Response to Comments

Second Periodic Review for the Spokane River Upriver Dam and Donkey Island PCB Sediment Site

**Public comment period held
September 27 – October 26, 2021
Facility Site ID 65178472, Cleanup Site ID 4213**

Washington State Department of Ecology
Spokane, Washington

Comment 5, Page 11 – Surface water, water chemistry results

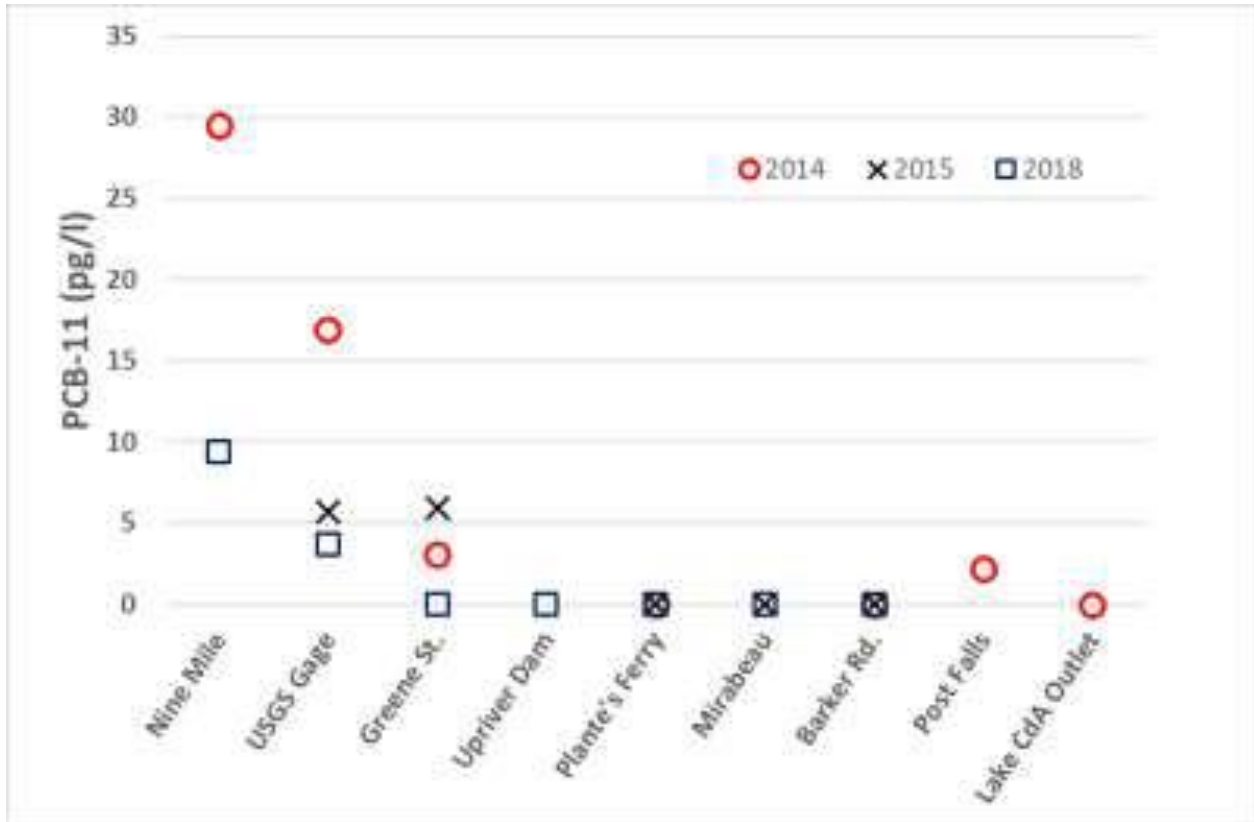
Based on the available data, the apparent seasonal increase in total PCB concentrations observed during September 2003 is indicative of surface water releases of predominantly PCB-11 to the river system between Plante's Ferry Park and Boulder Beach. This increase appears to be from treated wastewater discharged from the IEP outfall (Ecology 2002) located in this stretch of the river.

IEP requests that these statements be removed in their entirety since they are outdated and based on conjecture. There is no support for this conclusion contained in the report and the reference, Ecology 2002, is not included in the reference list, so it is unclear how Ecology determined the basis for this supposition. Additionally, as stated in Comments #2 and #3 above, industrial and municipal facilities upstream of this location have installed advanced wastewater treatment technologies capable of removing PCBs in excess of 99%. A recent internal study demonstrates that IEP is removing in excess of 99.99% of the total PCBs entering its facility using the most advanced wastewater treatment system in the pulp and paper industry. In lieu of referencing information that is no longer pertinent, IEP requests that Ecology recognize these efforts due to the relevance of these remedial actions for current and future improvements to this study area.

To further illustrate the disparity between current and past conditions, data collected by DH Environmental, Inc. in 2020 to support Ecology's Second Periodic Review did not detect any

concentrations of PCB-11 in the surface, sand or coal layers at the location of the Upriver Dam cap.

Furthermore, a recent study by LimnoTech (Technical Advisor to the Task Force), Sources and Pathways of PCB-11: Initial Investigations concluded the following regarding PCB-11: “Concentrations [of PCB-11 are] essentially indistinguishable from blanks at Upriver Dam and upstream.” The following graph resulting from this study illustrates the level of PCB-11 found throughout the study area over multiple years with essentially non-detectable levels of PCB-11 upstream of Upriver Dam:

Based on the overwhelming evidence provided above, it should be apparent that Ecology must present a periodic review that accurately represents current conditions and delete the requested paragraph that is erroneous and misleading.

The identified reference has been updated in the Periodic Review. The statement in question is a part of the RI/FS discussion in the Periodic Review. The brief overview of the RI/FS provides historical context about the nature and extent of contamination at the site and the reasons a cleanup action occurred. The focus of the Periodic Review is to evaluate whether the cleanup remedy at the site continues to protect human health and the environment. Evaluation of PCB concentrations and source control upstream of the site is outside the focus of the Periodic Review.

Comment #5, Page 11 – Surface Water, Water chemistry results:

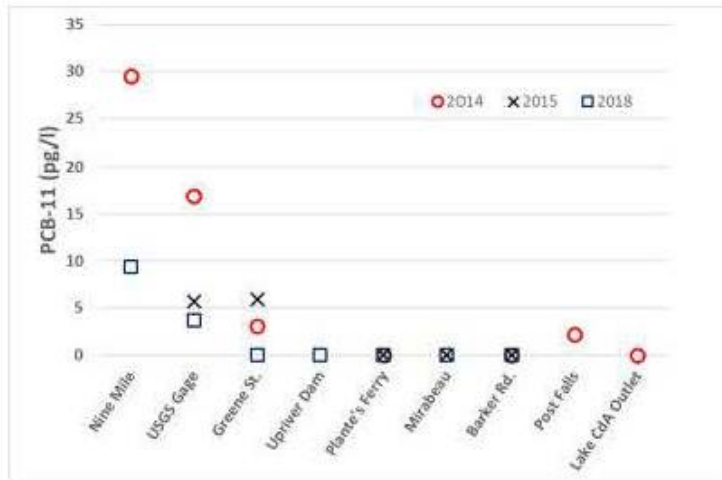
Based on the available data, the apparent seasonal increase in total PCB concentrations observed during September 2003 is indicative of surface water releases of predominantly PCB-11 to the river system between Plante's Ferry Park and Boulder Beach. This increase appears to be from treated wastewater discharged from the IEP outfall (Ecology 2002) located in this stretch of the river.

IEP requests that these statements be removed in their entirety since they are outdated and based on conjecture. There is no support for this conclusion contained in the report and the reference, Ecology 2002, is not included in the reference list, so it is unclear how Ecology determined the basis for this supposition. Additionally, as stated in Comments #2 and #3 above, industrial and municipal facilities upstream of this location have installed advanced wastewater treatment technologies capable of removing PCBs in excess of 99%. A recent internal study demonstrates that IEP is removing in excess of 99.99% of the total PCBs entering its facility using the most advanced wastewater treatment system in the pulp and paper industry. In lieu of referencing information that is no longer pertinent, IEP requests that Ecology recognize these efforts due to the relevance of these remedial actions for current and future improvements to this study area.

To further illustrate the disparity between current and past conditions, data collected by DH Environmental, Inc. in 2020 to support Ecology's Second Periodic Review² did not detect any concentrations of PCB-11 in the surface, sand or coal layers at the location of the Upriver Dam cap.

Furthermore, a recent study by LimnoTech (Technical Advisor to the Task Force), *Sources and Pathways of PCB-11: Initial Investigations*³ concluded the following regarding PCB-11: "Concentrations [of PCB-11 are] essentially indistinguishable from blanks at Upriver Dam and upstream." The following graph resulting from this study illustrates the level of PCB-11 found throughout the study area over multiple years with essentially non-detectable levels of PCB-11 upstream of Upriver Dam:

Based on the overwhelming evidence provided above, it should be apparent that Ecology must present a periodic review that accurately represents current conditions and delete the requested paragraph that is erroneous and misleading.
